L190-T940020-00-B

**Chicago Bridge & Iron**

**TELEFAX TRANSMISSION**

Attached are the following:  
 Nonconformance Report Nos. QT-10, QT-11, & QT-12  
 Assembly Check List Nos. REP-H1, REP-H2, REP-H3  
 REP-H4, & REP-H5  
 MISHAP REPORT No. 8434  
 Shop Release for Shipment Check List No. QT-H3

Report No. QT-10

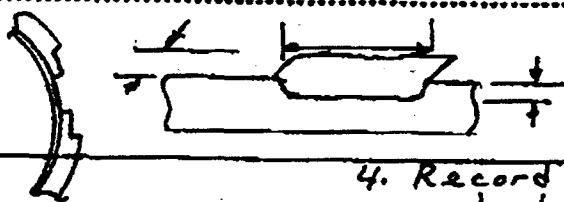
Copper deposit in Vacuum stiffener to Beam Tube  
Fillet weld.

1. Remove Vacuum Stiffener  
as shown

2. Chipp out Copper

3. Liquid Penetrant examine removal area

Per Above  
& Look at other  
welds for same.

4. Record Length, width  
and depth of repair  
cavity.

5. Weld cavity using  
WPS-ER302L/Repair

6. Splice New Segment of Vacuum Stiffener  
using splice details shown on Drawg No. 15  
for each end of segment.

7. Weld Fillet attachment on opposite  
Side

8. Visual Check Repair &  
record on Assembly Check List

Report No. QT-11

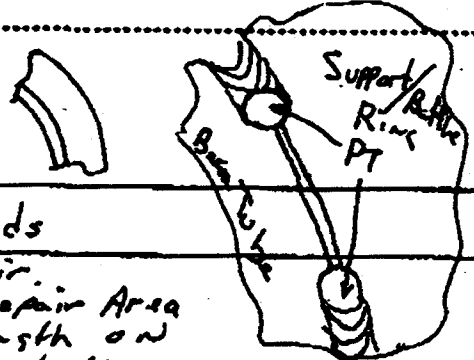
Fatigue Crack in Piece Mark 16-B-1 and  
16-A-2 used as shipping supports during  
shipment from Houston, TX to Plainfield, NJ.  
Two cracks in 16-B-1 8" and 7" Long  
One Crack in 16-A-2 2 1/2" Long

1. Remove Crack
  2. Liquid Penetrant Examine Weld Ends
  3. Repair Weld using WPS ER308L/Repair.
  4. Visual Check Repair Area & Record on Length on Assembly Check List
  5. Make a MESHAP Report per CALTech
- Corrective Action To Be Taken Per Above

Report No. QT-12

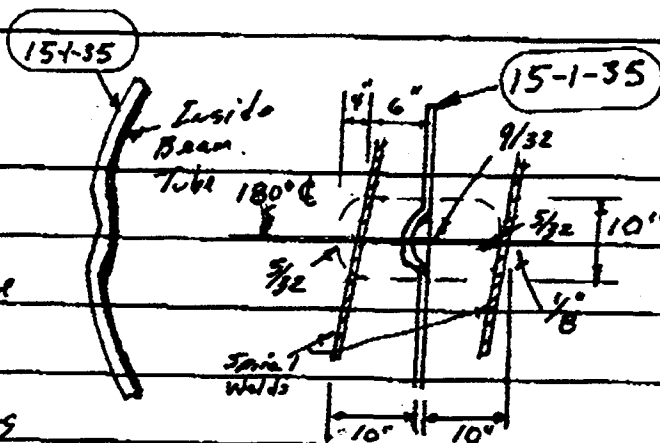
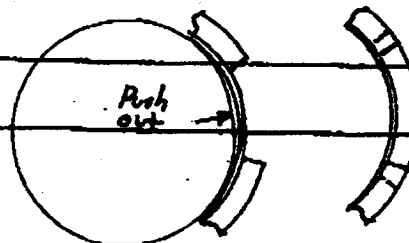
Assembly 21-D-1 dropped during handling at time of shipment Receiving (8/26/94)

Dent was made in Beam Tube and Vacuum Stiffener.

9/32" Depth X 10" wide X 20" Long

- Recommended Disposition:
1. Remove 1'-0 length of Vacuum Stiffener
  2. Push out Dent with turnbuckle fixture.
  3. Install Purse Boy (Segmental).
  4. Weld Segment of New Vacuum Stiffener per WPS-ER308L/Repair.
  5. Final Visual check Repair Area.
